Addendum

1.1 This addendum has been prepared to address a number of points raised by the *Hertfordshire Historic Environment Unit* following their consideration of the *Historic Buildings Record* for Plot 1500, Comet Way, Hatfield, prepared by the Heritage Network and dated January 2007 (HN Report no.387). The record was undertaken in response to conditions attached to planning consent for the conversion of the buildings (refs. S6/2006/442/FP & S6/2006/571/LB), granted by the Welwyn Hatfield District Council (WHDC)

Plot 1500, Comet Way
Hatfield, Herts.
HN624

Re: REFURBISHMENT OF EXISTING LISTED BUILDINGS AND ERECTION OF EXTENSION TO CREATE NEW POLICE STATION AND CRIMINAL JUSTICE CENTRE WITH ASSOCIATED PARKING – COMET WAY, HATFIELD: ARCHAEOLOGICAL IMPLICATIONS

Figure 7 (Revised)

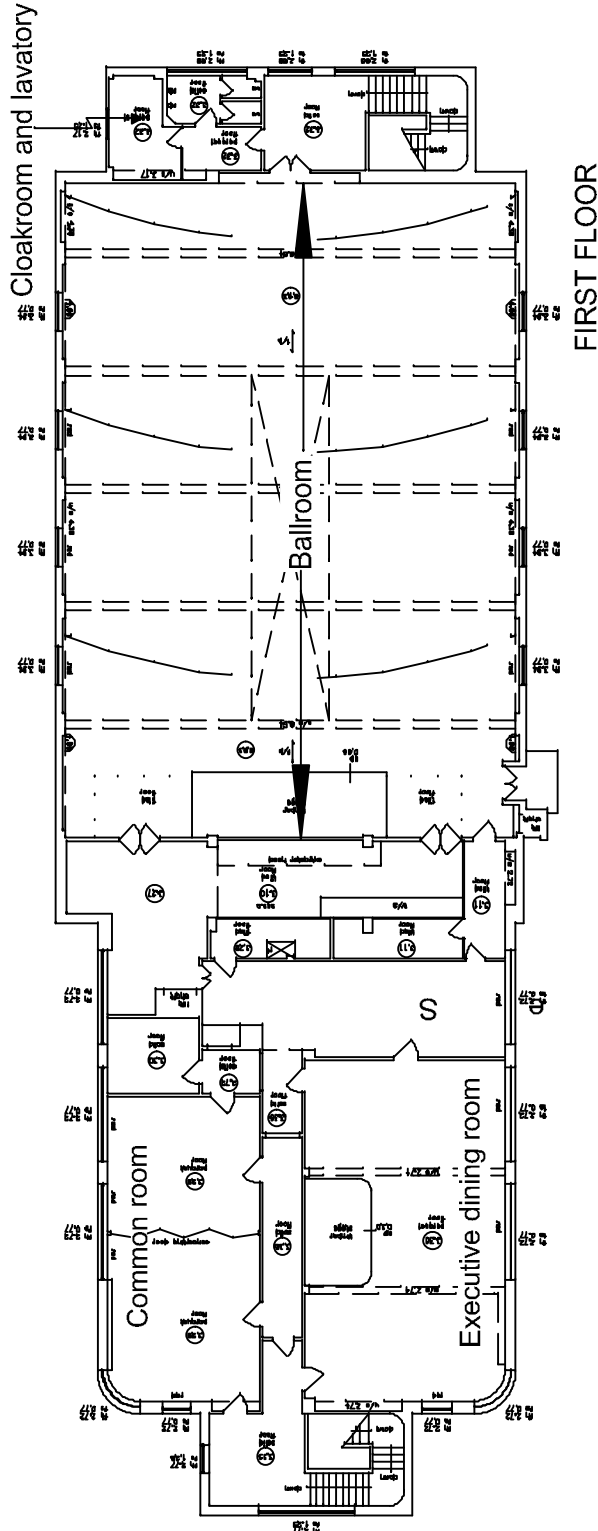
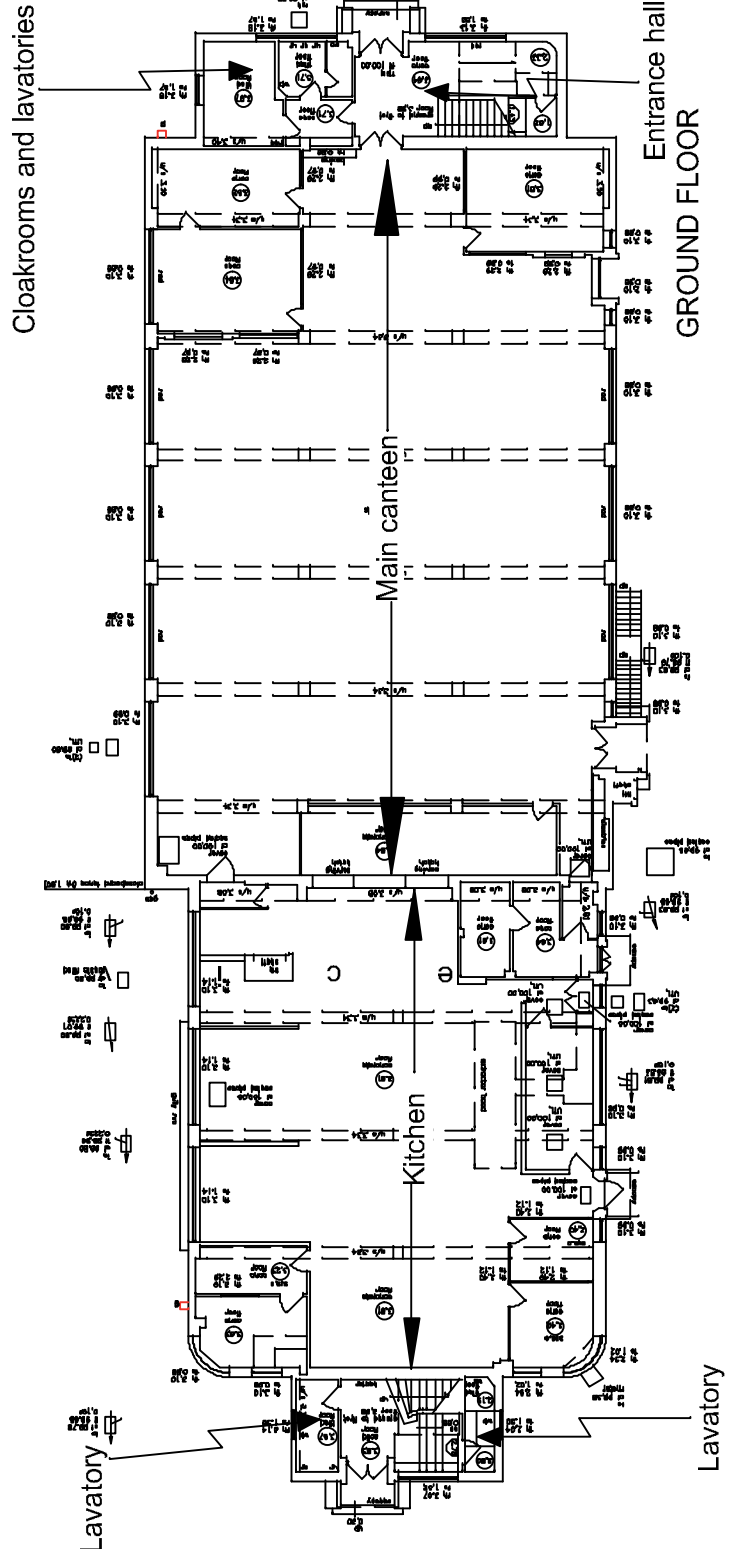
- The plans should be annotated so that rooms can be easily cross referenced with the text. For example figures 5, 6 and 7 and the discussion of the canteen block.
- Additional photographs of original fixtures and fittings that survive

Figure 7 (revised).....Canteen Block: Plans
